MSP-FET (v2.06)

Potential SPY-Bi-Wire issues

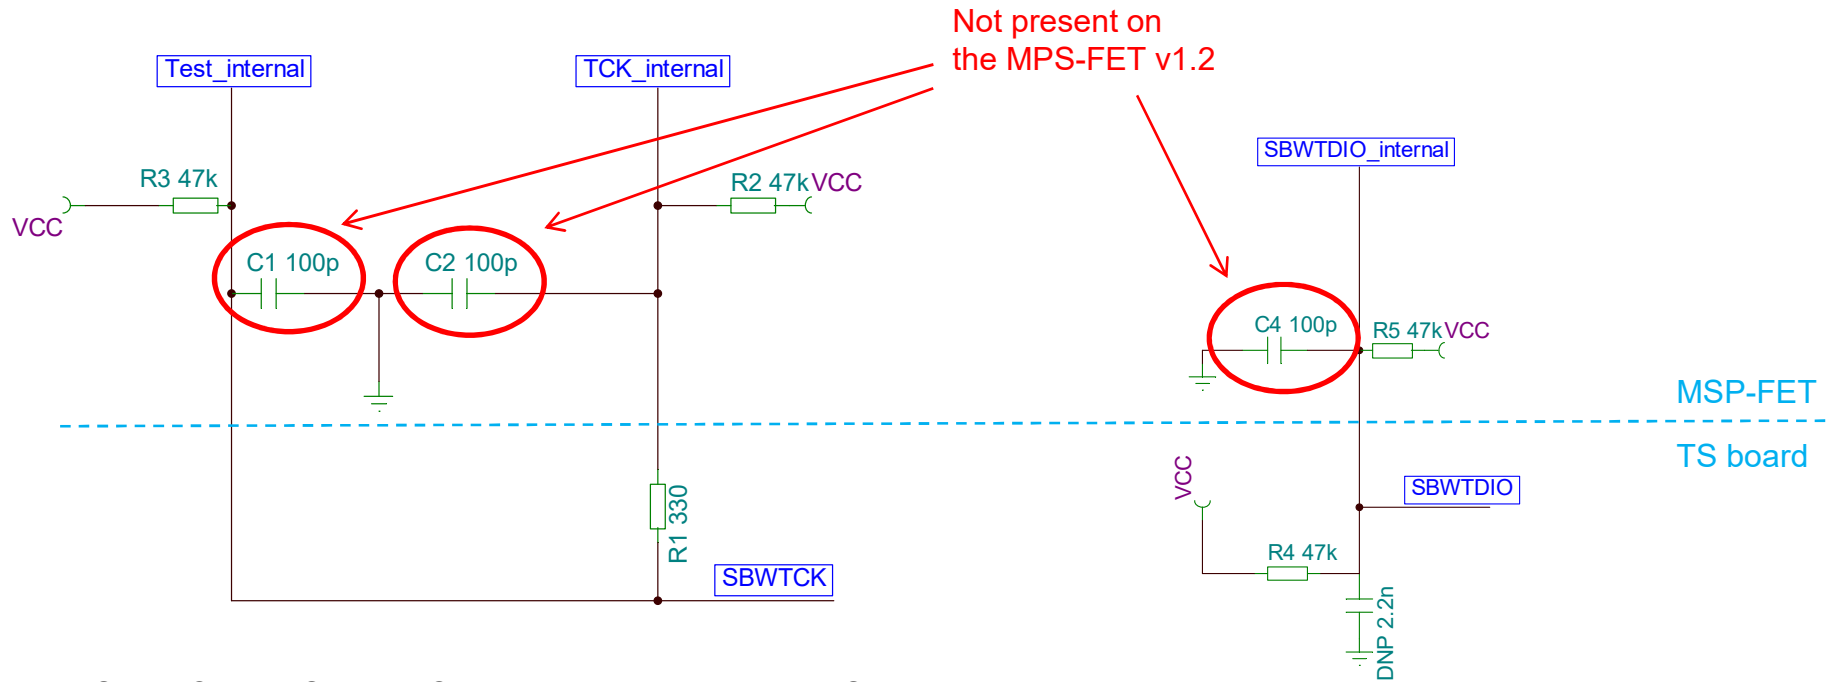
- New MSP-FET (v2.06) does not work in SBW mode with TS430-RHA40A (MSP430FR5739)
- Old MPS-FET (v1.2) is not affected, does work in JTAG and SBW mode

- SBWTCK has a larger capacity (C1+C2) than SBWTDIO (C4) with MSP-FETv2.06
- This leads to different timing behavior for the two signals
- The signals are not synchronized in time

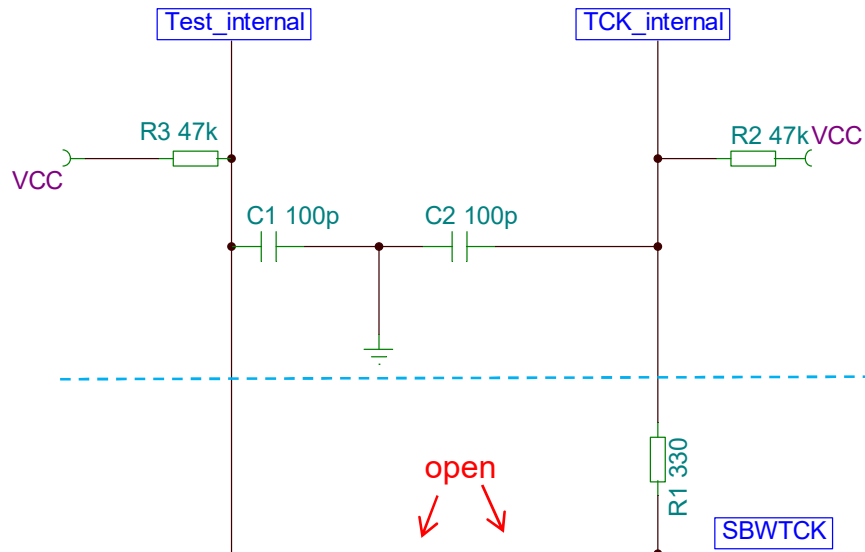
- SBWTCK and SBWTDIO have same capacity with MSP-FETv1.2
- Results in same timing behavior → signals are synchronized
